Likelihood and Reliability

Attachment 3

- Provide general response to RAI likelihood and reliability questions

Statistical Models

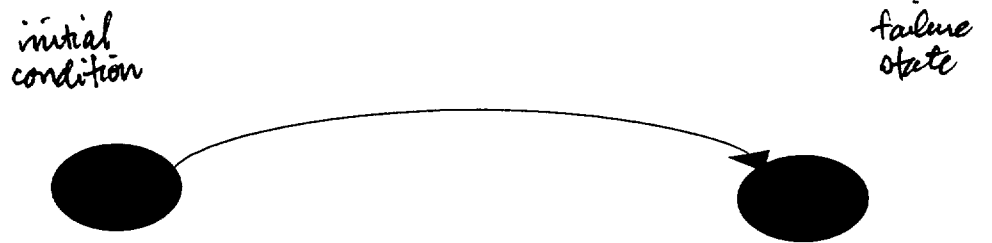
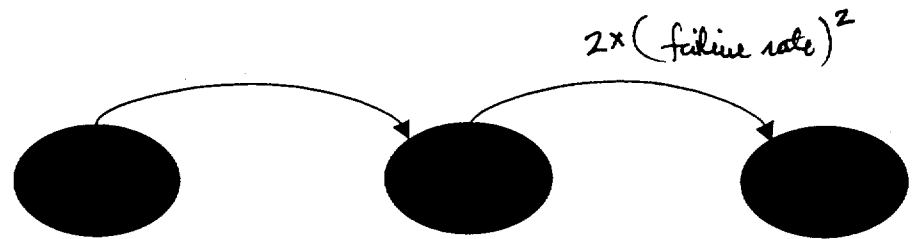
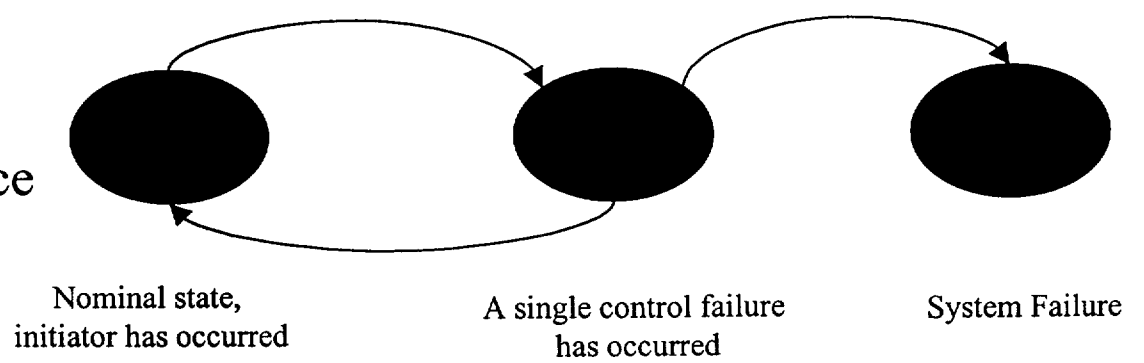
- Explain how the application of the single failure criteria or double contingency principle meets the performance criteria of 10CFR70.61
- Provide quantification of IROFS reliability or provide IROFS reliability targets

- Single Failure Criteria by itself may require rigorous reliability analysis to demonstrate Highly Unlikely Criteria is met
- However, Highly Unlikely Criteria is ~~easily~~ met with the application of the following:
 - Single Failure Criteria or double contingency principle
 - Management measures including IROFS Surveillance (IROFS failure detection and Repair or Process Shutdown)
 - 10CFR50 App B, NQA-1 QA Program *Such items are generally reliable to $< 10^{-2}$ failures per year.*
 - Industry Codes and Standards

Model 1:
Single Control Model

Model 2:
Single Failure Model
(double contingency model)

Model 3 (MFFF):
Single Failure and Surveillance

Results indicate that DCS commitments produce likelihood values that are equal to or lower than those provided in the SRP, thus satisfy the definition of highly unlikely
